SUNDRY NOTICES AND REPORTS ON WELLS

Big Sinks Draw 25 Fed Com 2H – Multi-bowl wellhead procedure

Devon Energy would like to propose a new casing design for the Big Sinks 25 Fed Com 2H with the following changes:

WELL NAME & NO.: | Big Sinks Draw 25 Fed Com 2H

SURFACE WELLHEAD LAYOUT UNIHEAD, UH-1,SOW, DEVON ENERGY, ODESSA

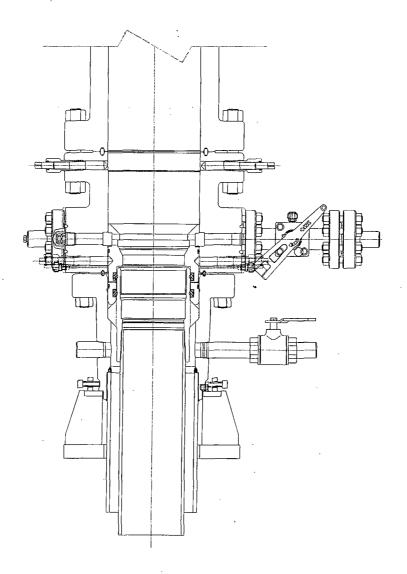
Devon proposes using a multi-bowl wellhead assembly (FMC Uni-head). This assembly will only be tested when installed on the surface casing. Minimum working pressure of the blowout preventer (BOP) and related equipment (BOPE) required for drilling below the surface casing shoe shall be 3000 (3M) psi.

- Wellhead will be installed by FMC's representatives.
- If the welding is performed by a third party, the FMC's representative will monitor the temperature to verify that it does not exceed the maximum temperature of the seal.

- FMC representative will install the test plug for the initial BOP test.
- FMC will install a solid steel body pack-off to completely isolate the lower head after cementing intermediate casing. After installation of the pack-off, the pack-off and the lower flange will be tested to 3M, as shown on the attached schematic. Everything above the pack-off will not have been altered whatsoever from the initial nipple up. Therefore the BOP components will not be retested at that time.

- If the cement does not circulate and one inch operations would have been possible with a standard wellhead, the well head will be cut and top out operations will be conducted.

- Devon will pressure test all seals above and below the mandrel (but still above the casing) to full working pressure rating.
- Devon will test the casing to 0.22 psi/ft or 1500 psi, whichever is greater, as per Onshore Order #2.

After running the 13-3/8" surface casing, a 13-5/8" BOP/BOPE system with a minimum rating of 3M will be installed on the FMC Uni-head wellhead system and will undergo a 250 psi low pressure test followed by a 3,000 psi high pressure test. The 3,000 psi high and 250 psi low test will cover testing requirements a maximum of 30 days, as per Onshore Order #2. If the well is not complete within 30 days of this BOP test, another full BOP test will be conducted, as per Onshore Order #2.

- 3. Operator has proposed a multi-bowl wellhead assembly. This assembly will only be tested when installed on the surface casing. Minimum working pressure of the blowout preventer (BOP) and related equipment (BOPE) required for drilling below the surface casing shoe shall be 3000 (3M) psi.

- a. Wellhead shall be installed by manufacturer's representatives, submit documentation with subsequent sundry.
 - b. If the welding is performed by a third party, the manufacturer's representative shall monitor the temperature to verify that it does not exceed the maximum temperature of the seal.

- c. Manufacturer representative shall install the test plug for the initial BOP test.
 - d. Operator shall perform the intermediate casing integrity test to 70% of the casing burst. This will test the multi-bowl seals.

- e. If the cement does not circulate and one inch operations would have been possible with a standard wellhead, the well head shall be cut off, cementing operations performed and another wellhead installed.

CONTINGENCY MODE

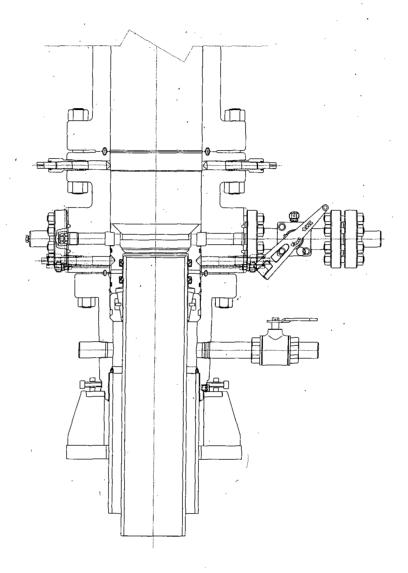
After running the 9-5/8' intermediate casing with a mandrel hanger, the 13-5/8" BOP/BOPE system with a minimum rating of 3M will already be installed on the FMC Uni-head.
